SERENA PARK

FINAL ENVIRONMENTAL IMPACT REPORT

City of Palm Springs
Case # 5.1327

0.2 AGENCY COMMENT LETTERS AND RESPONSE TO COMMENTS

Supplemental Line No. 3 Storm Drain Master Plan Routing (North Area)

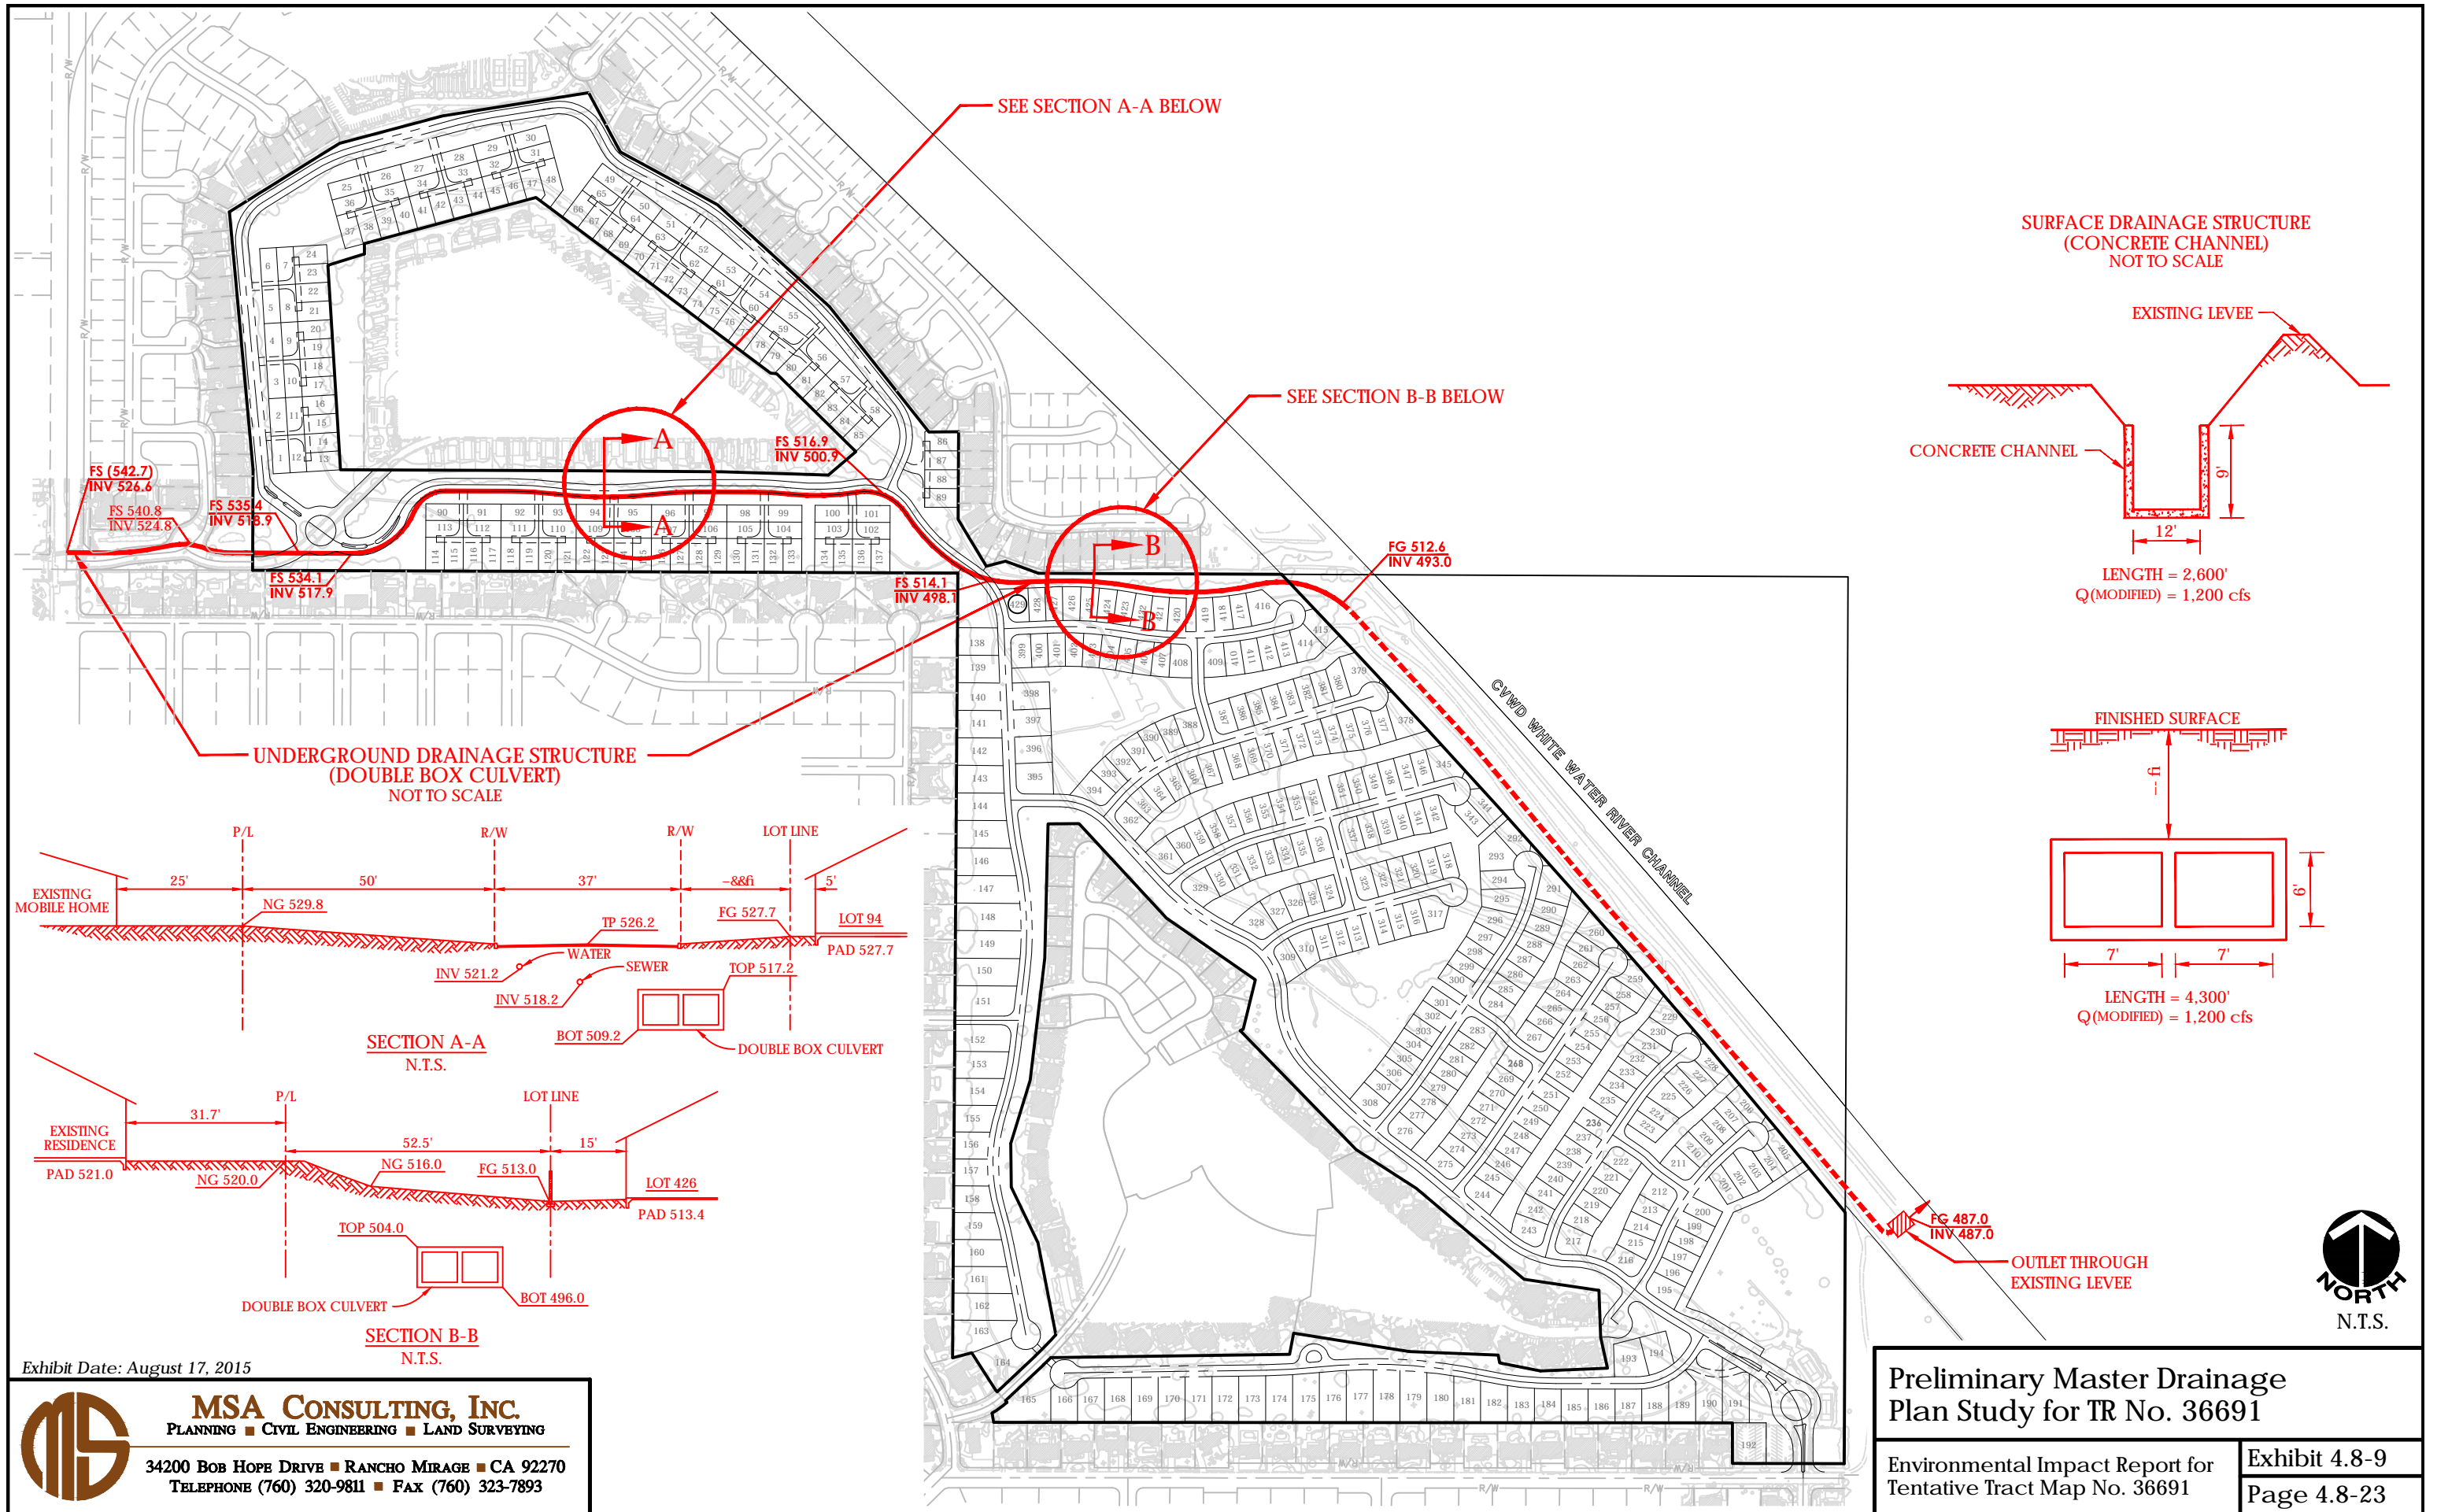
Subsequent to the end of the Public Review period for the Serena Park Draft EIR, City staff suggested the Draft EIR analyze the application of the Palm Springs Master Plan of Drainage (MDP), particularly the issue of timing of construction of Line 3, a major feature of the MDP that will traverse the property in an east-west direction. This line is the major conduit of storm flows from the northern area of Palm Springs into the Whitewater Channel, and to date no part of the of the storm drain facility has been constructed. It is uncertain when the storm drain facility will be constructed. Minor edits and additions have been made to the following sections to address the MDP Line 3. Sections 4.3, 4.8 and 4.15 are provided in their entirety to provide context, however text changes have only been made to specific pages as indicated below and new text is identified in *red Italics*:

Section 4.8 – Hydrology & Water Quality (Revised Pages 4.8-6 & 7, 4.8-18, 4.8-20 & 21, 4.8-24 & 25; 4.8-35 & 36) (Added Exhibits 4.8-2, 4.8-4, 4.8-5, 4.8-6, 4.8-8, and 4.8-9)
